Access Compliance Report

Public Rights-of-Way

| Intersection ID: 21919 | Main Street: NATIONS_FORD_RD | Cross Street: OLD_HEBRON_RD | Location: SE |
| ADA ID: 26760B24F54F | Ramp Type: ParaDiag | Initial Pass/Fail: Fail | Overall Compliance: No |

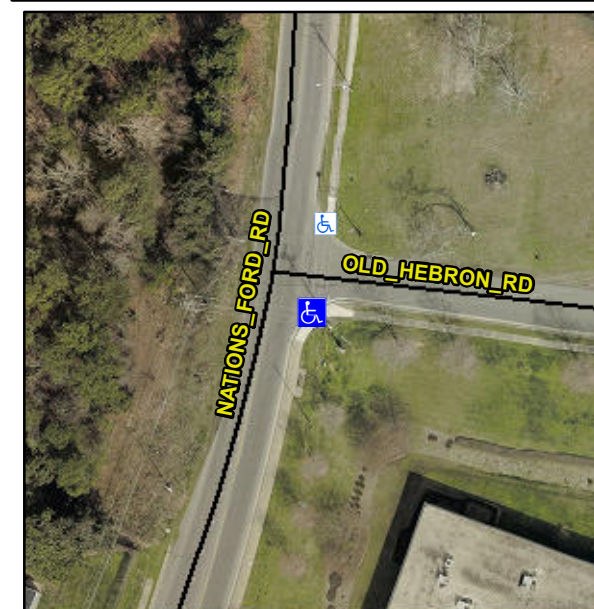
R304.3.2

| Compliance | Description | Data | Compliance | Description | Data |
|------------|----------------------|------|------------|-----------------------------|------|
| No | Ramp Slope LT (%) | 10.6 | Yes | Ramp Slope RT (%) | 7.2 |

Remove & Replace Curb Ramp With Two New Directional Ramps or Equivalent.
